COMMUNITY ROOTS  
HOUSING

DESIGN  
RECOMMENDATION  
SUBMITTAL

1323 EAST UNION STREET  
PROJECT # 3035728-LU

#### 1. 1. MASSING AND CONFIGURATION

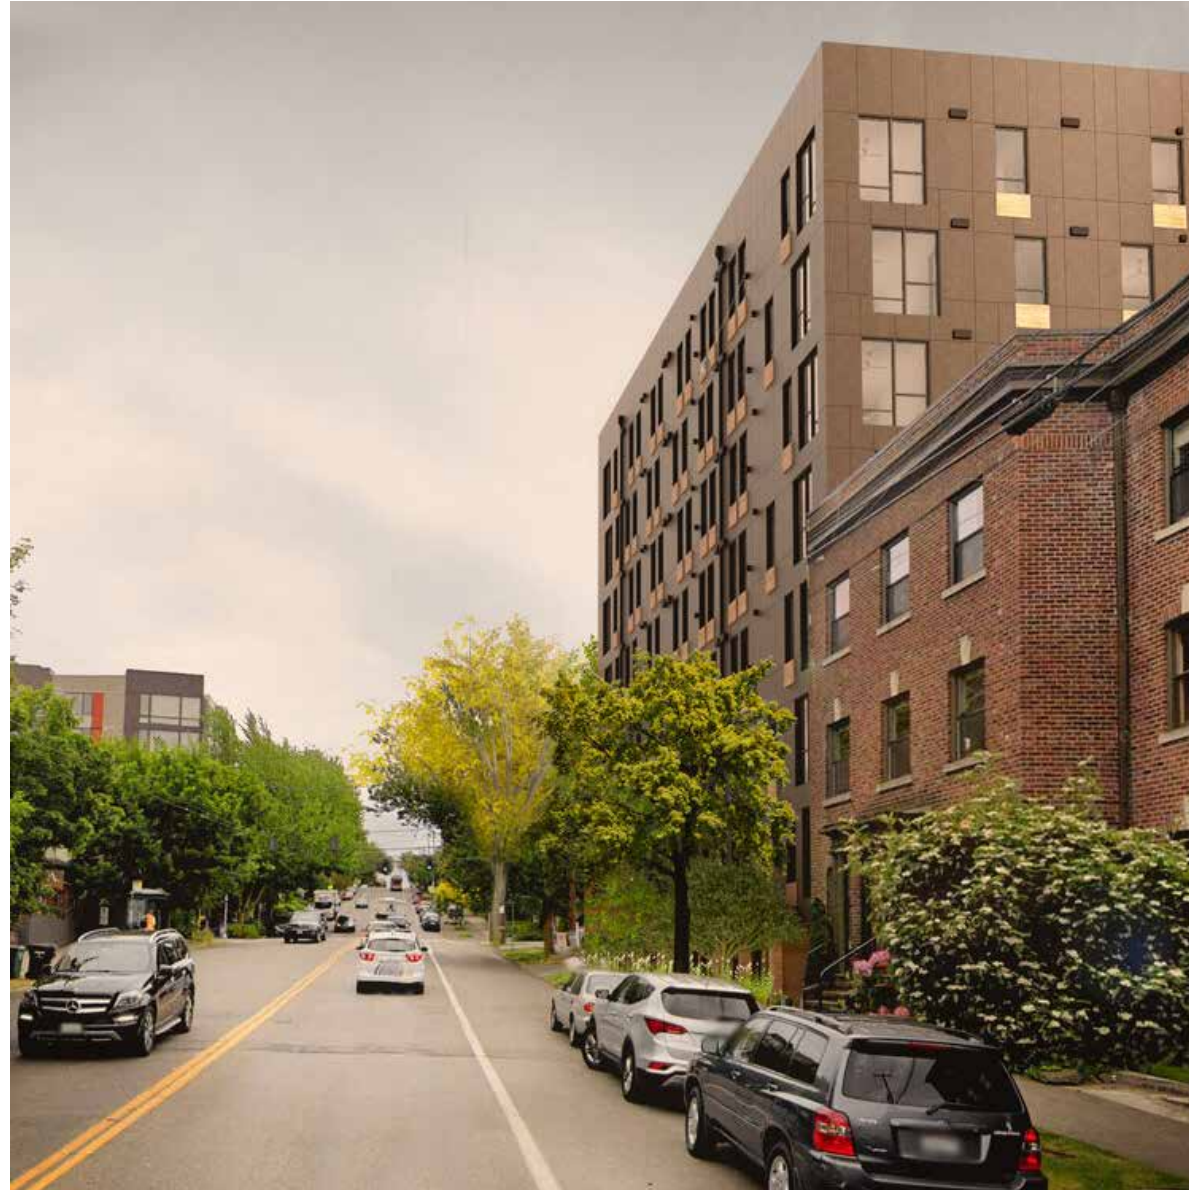
Modulation in the upper levels of the preferred massing will be prominently visible as the site is located at a major intersection within the neighborhood. Echoing public comment, Staff recommends breaking up the perceived bulk of the upper level massing through strategic application of the material palette and the use of secondary architectural elements.

The strong and simple massing marks the prominent corner in a modest and restrained way. The building's massing takes its cues from the unassuming, simple shapes of its two 100-year-old neighbors: the Helen V and the Texada Apartments, both clad in dark brick, and also the six-story 1310 E Union building across the street, clad in dark gray fiber-cement material.

By using clear and intelligible massing that reflects the clear massing of its neighbors, the building relates to the surroundings and the community in simple and direct ways, per Design Guideline DC2.1.a. Also, Design Guideline DC2.1.b recommends that the building meet the street level in a pedestrian-oriented way with human-scaled materials. The building meets this requirement by utilizing the warm wood colors of the cladding at the ground floor, delineation of the upper massing from the ground level, and the scale of the unit entryways.

Design Guideline DC4.2.a is met in the upper stories, using strong, dark materials with brightly contrasting wood-toned elements at the windows. The rhythm of the windows brings a visual interest and modulation in ways that intrigue the eye and break up the façade on E. Union St, per DC4.3.b,d. Finally, both prominent corners of the building, at 14th Ave and E. Union St., and at E. Union St. and the west easement, are marked vertically with larger windows, allowing these two important corners of the building to glow at night and open up generous territorial views from the units inside, per DC4.3.d. Please see preliminary draft renderings.

#### 1.2. MASSING AND CONFIGURATION

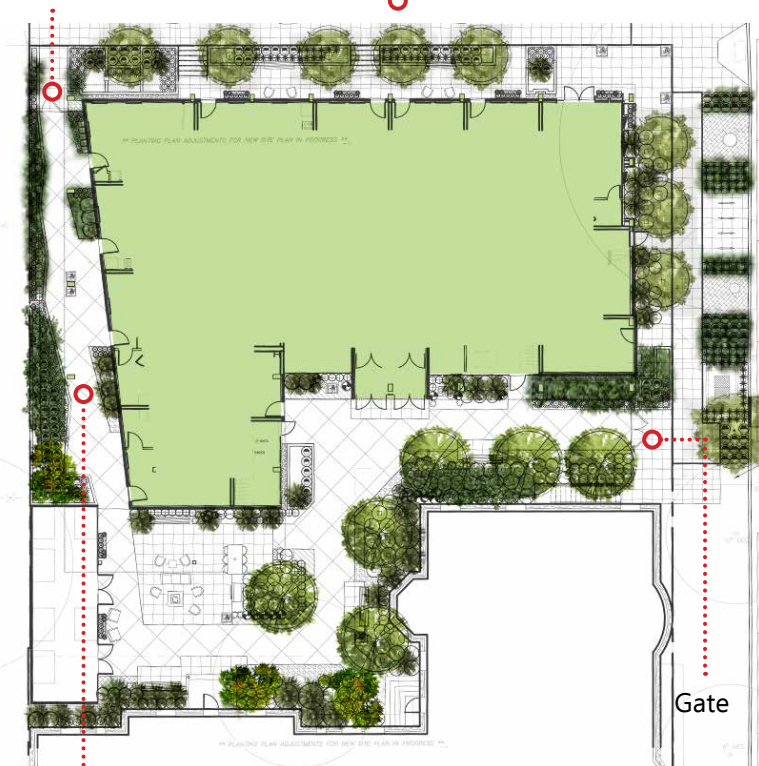
Incorporate some form of defensible space between the entries into the ground floor units along the alley/easement and pedestrians accessing the courtyard and entrance to the Helen V apartment building from E. Union Street.

Creating great pedestrian spaces, a lively streetscape, defensible unit entries, and usable residential exterior spaces are primary goals of the project. Taking cues from DC3.1.c, and PL3.1.h and PL3.2.d, the almost level entry off Union at the alley, under the sheltering building overhang, creates a welcoming secondary entry arcade to Helen V and our building, for use by all inhabitants. Using planters and bio-retention planters, per PL3.2.j, the project creates a number of unique exterior areas for the residents. In the entry arcade on the west side of the building, these include subtle spaces between the walkway and the studio entries. In front of each entry, semi-private spaces are created as a place to pause, before entering the semipublic walkway through the planters. Additional delineation of the space is created with different paving patterns.

Along Union, working with the grades, we have created stoops that gather two or three units together, to create a few small, semi-private, defensible spaces, in response to PL3.1.f, g, h, and PL3.2.h, i, j, and k. This strategy also responds to DC3.1.a creating a feeling of community between the units on Union. Similarly, a larger, more connected semi-private space for the residential units alongside the easement is created along the West facade, recessed at the ground level. Four-foot-high gates at the Union/easement space, as well as the main entry off 14th, help create a sense of security, without being overly defensive.

#### 2. 1. FACADE COMPOSITION

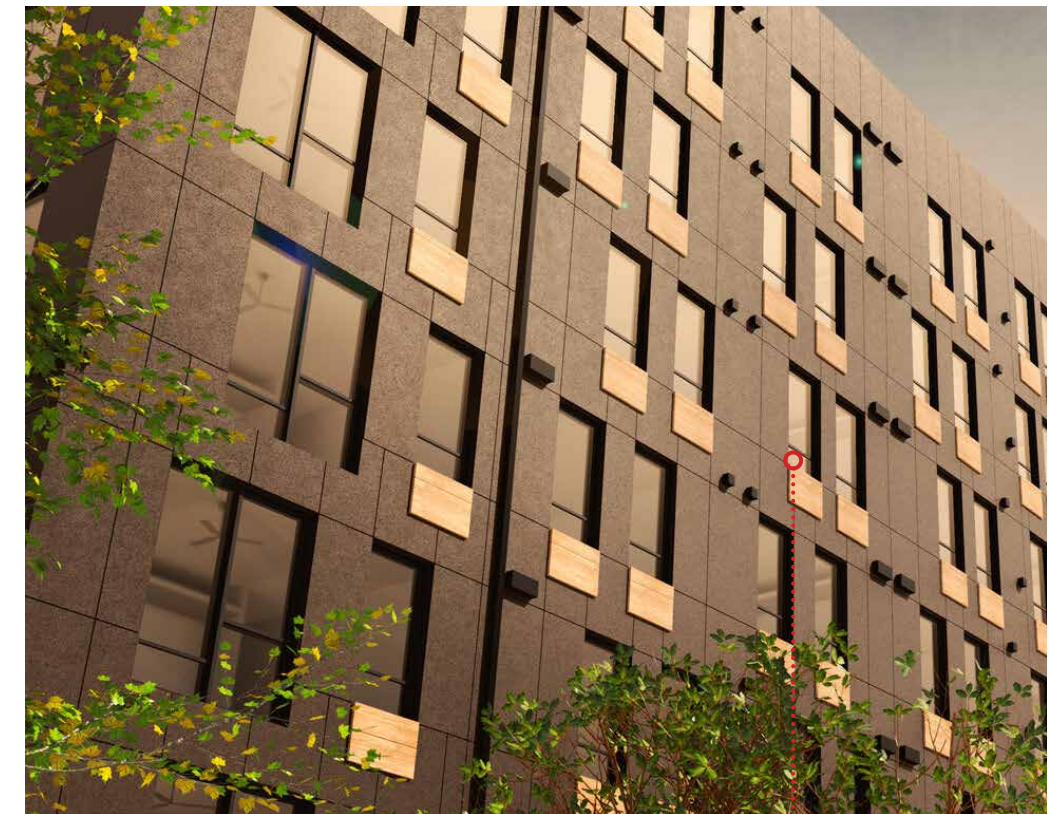
Recommended is a selection of a material palette that fits well into the neighboring context, applied in a manner that helps break down the massing to a more appropriate scale. In addition, neighboring structures can influence material selection and application strategy, especially along E. Union Street, where strong datum lines are established.

The building is designed to convey dignity and timelessness. The façade palette is simple, evoking a timeless nature of urban residential facades, per Design Guideline DC2.1.a. These proportions are also created by using elongated, vertical windows, with dark window frames; however, per Design Guideline DC4.2, a warm-textured wood-toned material is added at the base of the windows for bright contrast and to further elongate the window element. These proportions evoke some of the simple and strong lines of the many residential buildings of the Central District, including the two dark brick buildings that flank the site – the Helen V to the south and the Texada Apartments to the west. The rich dark color of the fiber-cement panels, mounted in vertical 2' to 4' wide segments, and the window patterns, alternating both vertically and horizontally, create a subtle variation and rhythm up and across the façade that changes as one walks up E. Union Street and around the building. Per DC4.3.b and d, this visual movement reflects the changing rhythm of the units inside, responding to the activity of street outside, against the building with its simple and strong forms.

Texada Apartments to the west of the proposed building, along with the historic Helen V Apartments to the south, possess simple and strong lines in both massing and fenestration.

In response to the surrounding context, fenestration is created using elongated vertical windows and rich dark color of the cladding. A new rhythm is created using these historic neighborhood elements by alternating window and cladding placement horizontally and vertically.

#### 2. 3. FACADE COMPOSITION

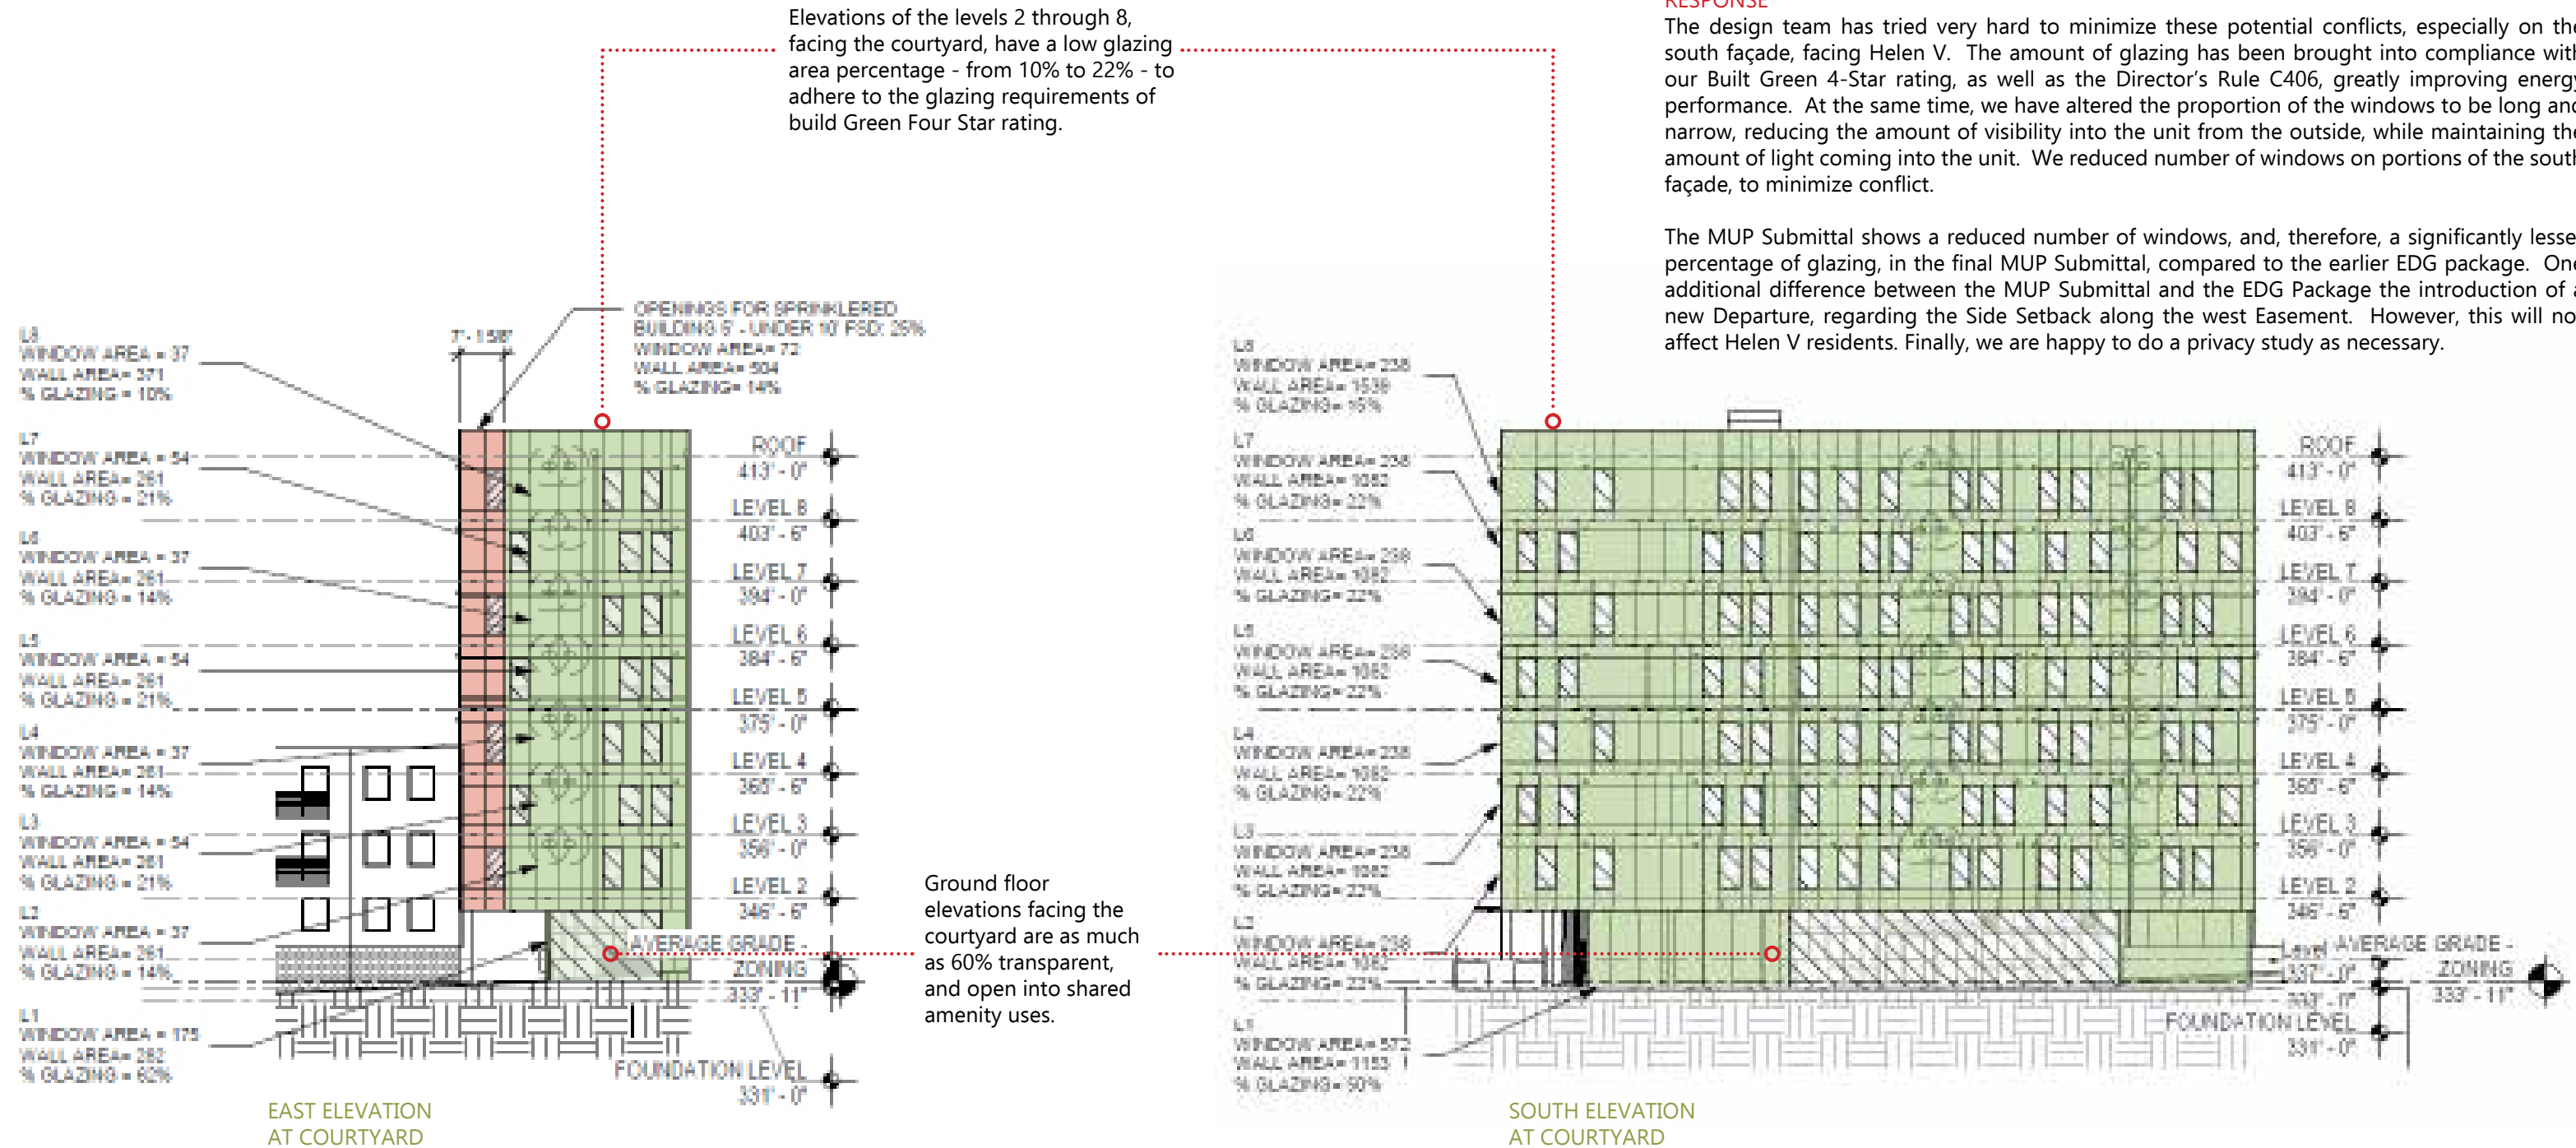
There is a concern regarding potential privacy issues with residents in the adjacent Helen V apartment building. In developing the façades, fenestration should minimize overlap with the existing apartment building. A privacy study shall be provided at recommendation.

The design team has tried very hard to minimize these potential conflicts, especially on the south façade, facing Helen V. The amount of glazing has been brought into compliance with our Built Green 4-Star rating, as well as the Director's Rule C406, greatly improving energy performance. At the same time, we have altered the proportion of the windows to be long and narrow, reducing the amount of visibility into the unit from the outside, while maintaining the amount of light coming into the unit. We reduced number of windows on portions of the south façade, to minimize conflict.

The MUP Submittal shows a reduced number of windows, and, therefore, a significantly lesser percentage of glazing, in the final MUP Submittal, compared to the earlier EDG package. One additional difference between the MUP Submittal and the EDG Package the introduction of a new Departure, regarding the Side Setback along the west Easement. However, this will not affect Helen V residents. Finally, we are happy to do a privacy study as necessary.

#### 3.1 PRIMARY ENTRIES AND GROUND LEVEL USES

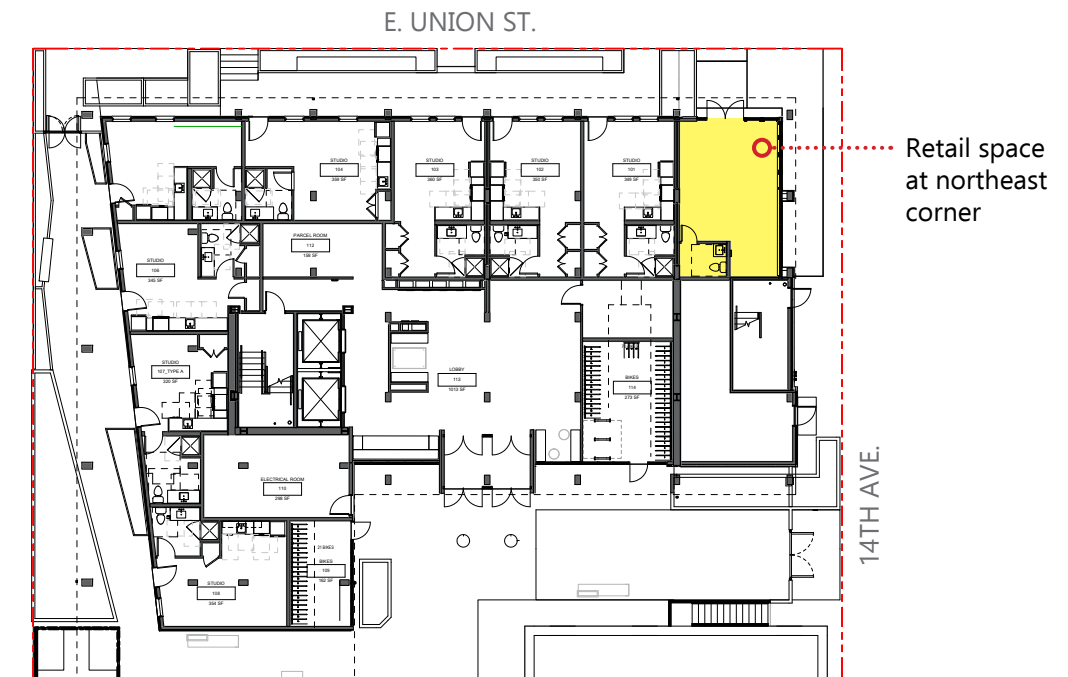
The design of the commercial space should differ from that of the adjacent residential uses and have a distinct character. Recommendation is to provide ample glazing to increase visibility into the space from the public realm.

The project includes a small commercial space at the prominent corner of 14th Ave. and E. Union St. In order to differentiate the commercial space from the residential units next door, we designed it with Design Guidelines PL3.1.b,c,d and PL3.2.b,d in mind. The commercial space has a two-story tall interior, with significant storefront glazing on both E. Union St. and 14th Avenue. Working closely with the existing street grades, we designed the entry as level and accessible as possible.

Vertical blade signage, signs along the spandrel panels and over the door of the storefront along the 14th Ave. and Union St. facades are designed to provide as much identity for the commercial space as possible, ensuring its success. Additionally, a separate address will be implemented to focus the importance of the identity of the commercial use at the corner: while the apartment building is addressed 1323 E. Union St., the retail space will be 1321 E. Union St.

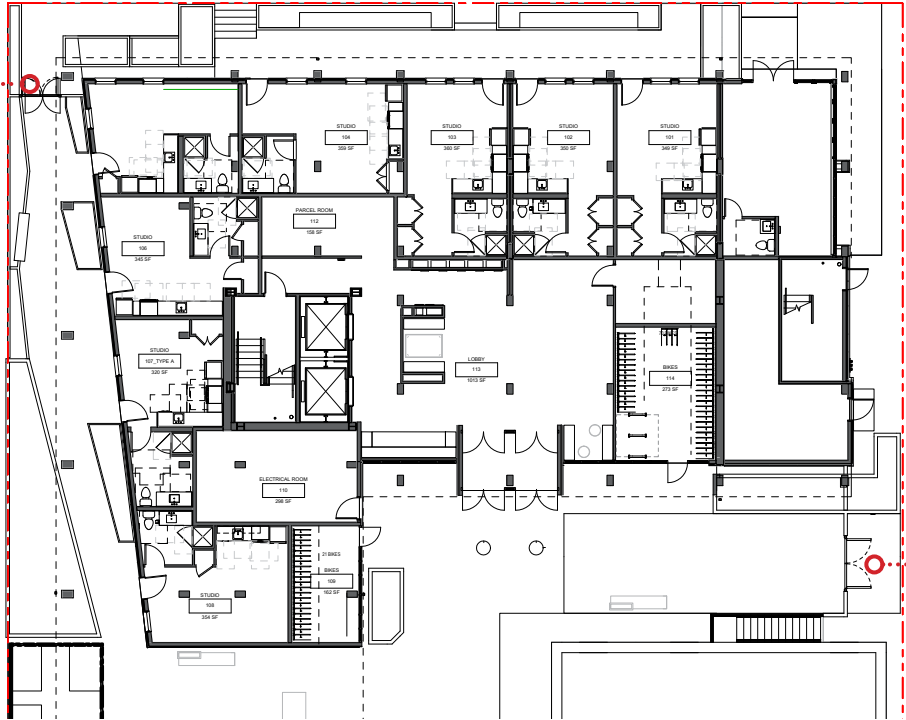
4.1 COURTYARD AMENITY AREA  
Staff recommends exploring how the intended usability of this area will continue to influence the design, as the project evolves and suggests incorporating different hardscape materials to help delineate the public and private spaces along the alley at the western edge of the site.

**RESPONSE**  
Landscaping plans have been developed per PL1.2.d, showing different materials and colors at the ground level. The changes in materiality help differentiate spaces that border or edge the main gathering spaces of the courtyard, entry walkways, and gathering areas in the courtyard's center. Additional multiple spaces have different roof conditions – they are either open to the sky, or sheltered under an overhang or an arcade – providing multiple types of experiences in the courtyard.
